# 17 Branch Hill - 2018/2636/P

<b>Delegated Report (Members Briefing)</b>		<b>Analysis sheet</b>	<b>Expiry Date:</b>	<b>21/08/2018</b>
		N/A	<b>Consultation Expiry Date:</b>	<b>29/07/2018</b>
<b>Officer</b>			<b>Application Number(s)</b>	
David Peres Da Costa			2018/2636/P	
<b>Application Address</b>			<b>Drawing Numbers</b>	
17 Branch Hill London NW3 7NA			Refer to Draft Decision Notice	
<b>PO 3/4</b>	<b>Area Team Signature</b>	<b>C&amp;UD</b>	<b>Authorised Officer Signature</b>	
<b>Proposal(s)</b>				
Variation of condition 2 (approved plans) of planning permission 2015/3377/P dated 27/04/2017 (for erection of part 2 and part 3 storey plus basement single family dwelling (following demolition of existing) with plant room, swimming pool (including air handling unit) and 5 condenser units), namely to relocate 2 condenser units to acoustic enclosure in south east corner of garden.				
<b>Recommendation(s):</b>		Grant planning permission subject to s106 Agreement

**DECISION**  
Proposal:  
Variation of condition 2 (approved plans) of planning permission 2015/3377/P dated 27/04/2017 (for erection of part 2 and part 3 storey plus basement single family dwelling (following demolition

Site photos

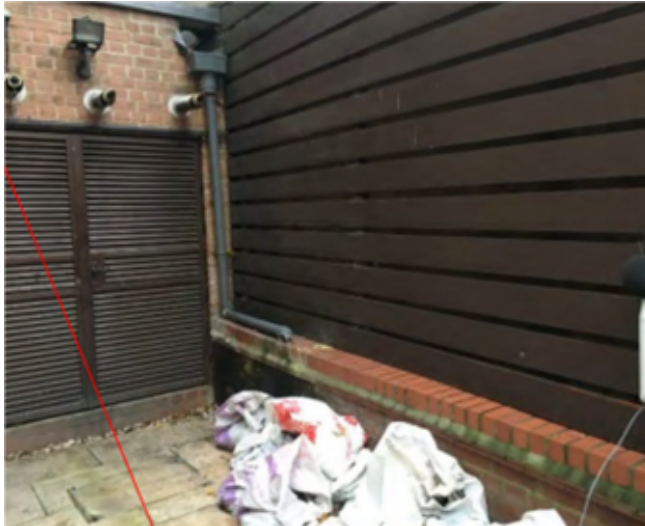
<b>CAAC comments:</b>	<p><u>Heath and Hampstead Society</u> - Object</p> <p>This variation to move noisy equipment to the corner of the garden and much nearer to neighbouring gardens and houses is not acceptable. The approved position of the equipment was acceptable but the new position is not.</p> <p><i>Officer's comment: A noise report has been submitted which shows the units would comply with the Council's noise thresholds. A noise condition would ensure there would be no harm to neighbouring amenity.</i></p>

- 1.1. Consent is sought to relocate 2 condenser units to a proposed acoustic enclosure in the south east corner of the garden. The acoustic enclosure would be located adjacent to the rear boundary of 1 Branch Hill and the side boundary of Leavesden (the property to the south east of the subject property). The acoustic enclosure would measure 2m by 4.1m and would be 2.35m high and would have louvres.

- 2.5. An acoustic report has been submitted to support the application. The acoustic report has been assessed by the Council's environmental health officer and is considered acceptable. The nearest noise sensitive windows to the condenser units are the rear windows of No 1 Branch Hill (The Chestnuts) which are approximately 10m away. The lowest background noise level is 34dB during the daytime and 32dB for the night time. In order to comply with the Council's noise thresholds, the noise at the nearest noise sensitive façade should not exceed 24dB during the daytime and 22dB at night. The mitigation measures which would be included are as follows:

(a) Acoustic enclosure

(b) Acoustic Kits (top and side attenuators) are fitted to both condenser units.

(c) Both units to operate in low noise mode during the night time period (23:00 to 07:00).

- 2.6. It is also recommended that the condensers are mounted on anti-vibration mounts to minimise the transmission of structure borne sound to other parts of the building. The acoustic and anti-vibration mitigation measures would be secured by condition.
- 2.7. The calculated noise from the condensers with mitigation at the nearest noise sensitive facade is 20dBA during the daytime and 11dB during the night. This would meet the Council's requirements. A noise condition would be included on the decision to ensure the Council's noise thresholds were not breached.
